# SERVICE BULLETIN

Model	Applicable To	File Under	Bulletin No.
1992 - 95 PRELUDE 1992 - 93 CIVIC 4-DOOR	See VEHICLES AFFECTED	BODY	92-047
			Issue Date
			OCT 24, 1994

## Rearview Mirror Reinstallation (Supersedes 92-047, dated November 30, 1992)

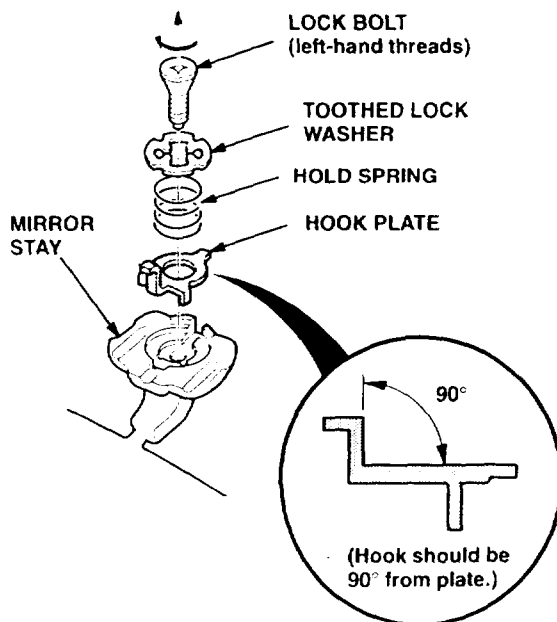
The rearview mirror may be accidentally knocked off the windshield lug and some of the internal parts can be broken or lost.

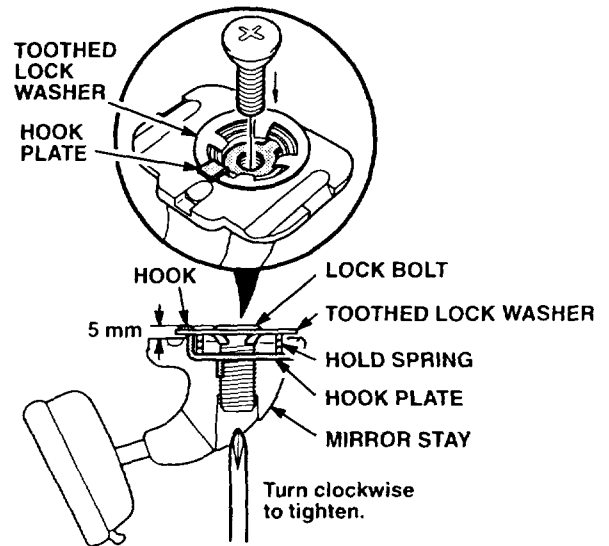
1. Remove the lock bolt from the mirror stay as described in the appropriate service manual.
2. Inspect the hook plate. If the hook plate is distorted, bend it to its original 90° position.

3. Inspect the lock bolt, the toothed washer, and the hold spring. Replace any parts that are missing, broken, or distorted (see PARTS INFORMATION).

4. Loosely install the hook plate, hold spring and the toothed washer to the mirror stay using the lock bolt. Make sure the hook plate is over the top of the toothed washer. Thread in the lock bolt until the toothed washer is approximately 5 mm from the mirror stay.

5. Install the mirror on the windshield lug, and torque the lock bolt to 2.0-3.0 N-m (20-30 kg-m, 14-22 lb-ft).
